HEARING DATE: February 16, 2023

SUBJECT: Alexanders Landing Subdivision
H-2022-0084

Annexation of 5.23 acres of land from RUT in Ada County to the R-8 zoning district and preliminary plat consisting of 24 building lots and 4 common lots for Alexanders Landing Subdivision.

B. Preliminary Plat (dated: 12/15/22)

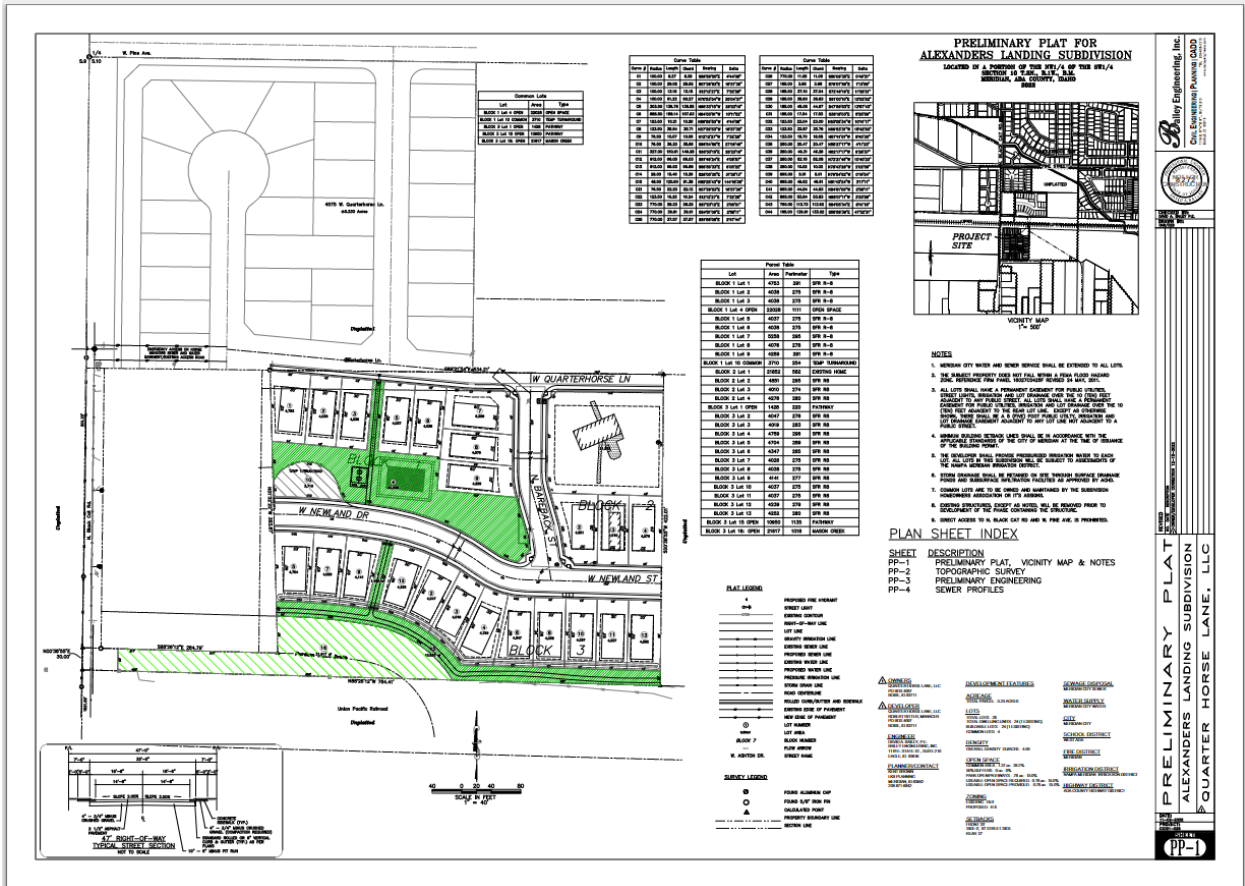
2. The final plat shall include the following revisions:
 - a. Depict an easement for the Purdam Gulch Drain, which runs along the southern boundary of this property.

- b. Depict a 10-foot wide multi-use pathway on common Lot 15, Block 3 per the Master Pathways Plan; provide the pathway within a 14-foot wide public pedestrian easement and include the recorded instrument number on the Final Pat.

- c. The temporary turnaround area on Common Lot 10 shall be landscaped in accord with UDC 11-3G-3E or transfer the temporary turnaround area to a buildable lot so it is not constructed on the common open space.

- d. Graphically depict the ACHD storm water drainage easements referenced in Note #6.
 - e. The existing home shall obtain a new address upon development of this project consistent with the development of the new local street.

E. Conceptual Building Elevations

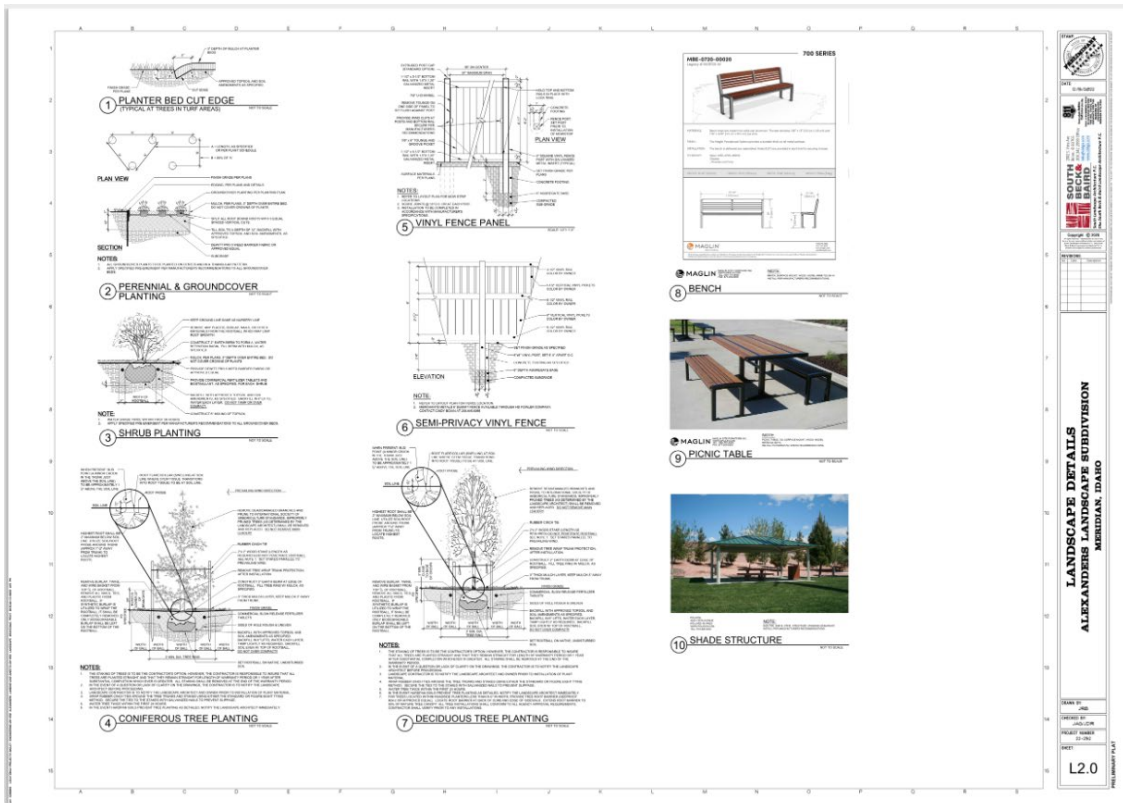
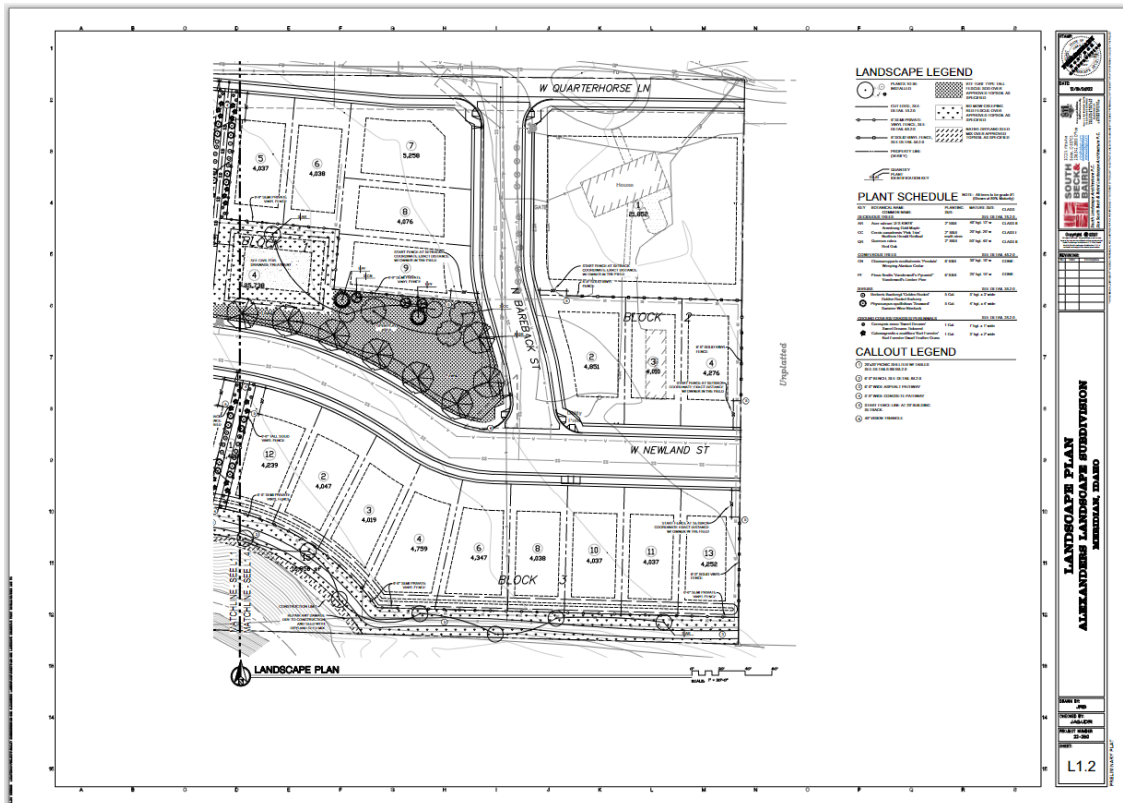
Building Elevations: Three (3) conceptual building elevations and floor plans were submitted that demonstrate what future homes in this development will look like (see Section VIII.F). Variations of two-story homes with a two-car garage are proposed. **The submitted elevations depict a number of different architectural and design styles with field materials of lap siding, differing color accents, roof profiles, and varying of home styles. Staff recommends that the Applicant add additional stone or brick accents to the front of the homes to provide more of a variation in materials.**

9. The Applicant shall comply with all ACHD conditions of approval.
 10. Direct access to N. Black Cat Road and W. Pine Avenue is prohibited.
 11. The Applicant shall submit revised elevations that include a mix of stone and/or brick *prior* to the Council hearing.
